TOWN OF PORTOLA VALLEY

1. Preliminary Architectural Review of an addition/remodel at 3915 Alpine Road- Alpine Inn; File # PLN_ARCH0022-2021 (J. Garcia)

SUBJECT: Preliminary Architectural Review of an addition/remodel at 3915 Alpine Road- Alpine Inn.

1 OUTDOOR LIGHTING PLAN
 1/8" = 1'-0"

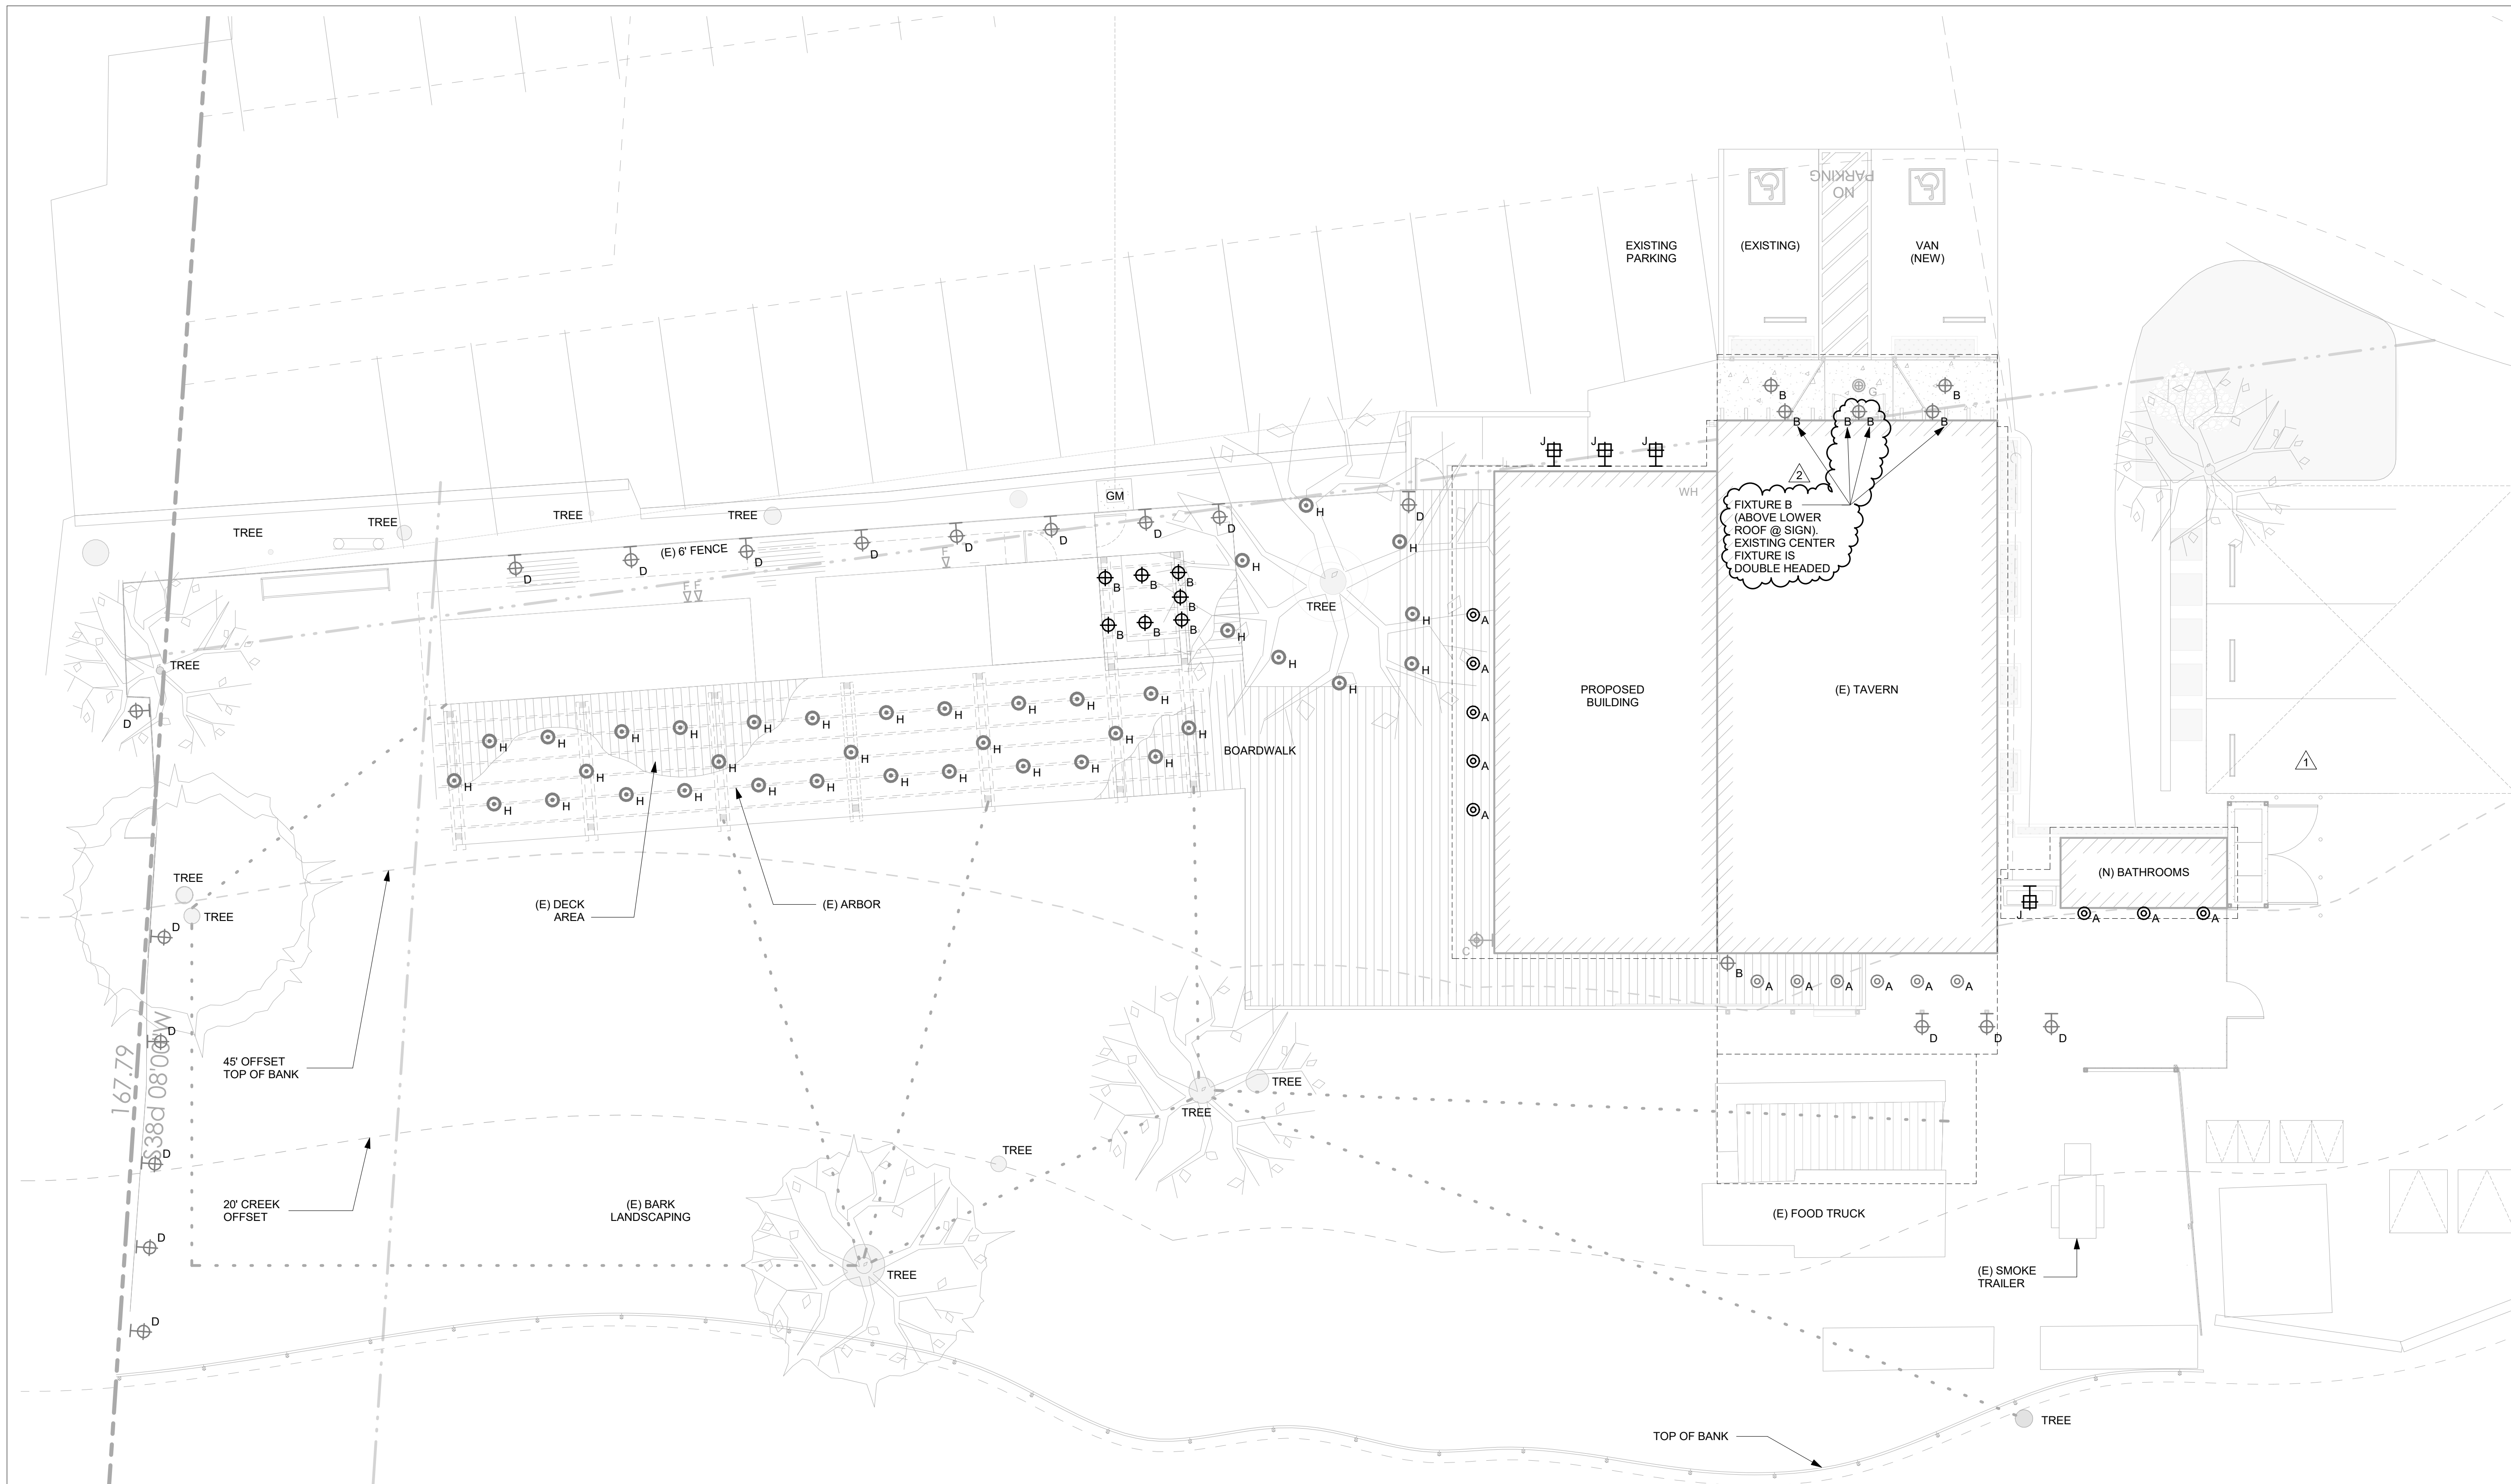
Exterior lighting plan is shown on sheet OL1 of the project plans and exterior lighting cutsheets for the proposed and existing lighting (as available) are provided on sheets OL2-OL4 (Attachment 2). New exterior lighting is proposed under the eaves of the kitchen addition, the bathroom addition, the detached outdoor bar as well as along the front of the restaurant at the kitchen addition. The existing house includes two light fixture styles including wall lights and

The previous ASCC approvals for the seasonal tent required the applicant to submit a revised lighting plan for review and approval by two members of ASCC. That process was delayed due to COVID-19 and the ASCC should review the exterior lighting plan for approval of both the newly proposed lighting and the lighting subject to the previous ASCC review. Of the existing lighting, light fixtures E, F and G have been revised to better meet the Town’s exterior lighting requirements and are now dark sky compliant. Staff has advised to revise light fixture F because it exceeds the maximum light brightness allowed by the Town, the applicant is requesting to the ASCC to keep Light Fixture F. The ASCC may wish to consider the number of lights, fixture style and or the lighting brightness of proposed and existing lighting relative to the proposed use. All lighting is summarized in the below table.

- The location of the proposed Transformer pad, and the mitigation measures to screen from the Public-Right of Way and Alpine Road Trail.
- The proposed lighting plan associated with the addition remodel proposal and whether it is appropriate or not. And review the existing lighting that has been recently revised to comply with the Towns Outdoor Lighting Ordinances.
